# Before the FEDERAL COMMUNICATIONS COMMISSION Washington, DC 20554

| In the Matter of Viasat, Inc. Applications for Earth Station Licenses | File Nos. SES-LIC-20210323-00557; SES-LIC-20210323-00559; SES-LIC-20210402-00613; SES-LIC-20210402-00609; SES-LIC-20210402-00610; SES-LIC-20210402-00609; SES-LIC-20210402-00610; SES-LIC-20210402-00611; SES-LIC-20210416-00706; SES-LIC-20210416-00707; SES-LIC-20210416-00709; SES-LIC-20210416-00713; SES-LIC-20210416-00715; SES-LIC-20210719-01082; SES-LIC-20210719-01082; SES-LIC-20210719-01082; SES-LIC-20210719-01083; SES-LIC-20210416-00714  Call Signs: E210056; E210057; E210058; E210067; E210068; E210063; E210064; |

#### REPLY IN SUPPORT OF VERIZON'S PETITION

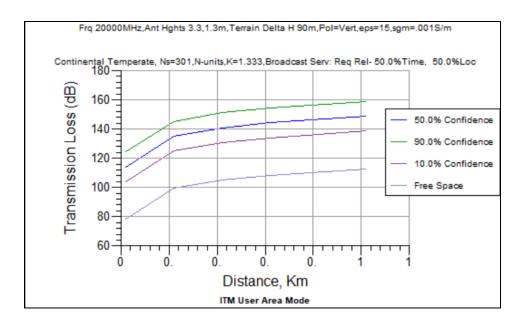
Viasat defends its use of NTIA's Irregular Terrain Model ("ITM") as "transparent." But Viasat's purported transparency does not change the fact that the ITM model is from 1984 and for frequencies between 20 MHz and 20 GHz. Indeed, when Verizon attempted to recreate the earth stations' contours using an executable version of the model on NTIA's website, the model would not run for frequencies above 20 GHz and the following error message appeared:

Even if Viasat's use of the ITM model were justified (which it is not), Viasat has not been transparent in providing the assumptions that it used to model clutter loss, or the outputs of the model that its Applications reflect. For example, Viasat failed to disclose statistical parameter inputs required to run the model, such as the percentage of time and percentage of locations, as well as other inputs such as surface refractivity, conductivity of ground, and dielectric constant of ground. Even if Verizon could deduce these inputs (which it cannot), Viasat also failed to provide the confidence level that its transmission loss reflects. Below is a sample output from the ITM model showing the variability in results at 20 GHz depending on the confidence level assumed.<sup>9</sup>
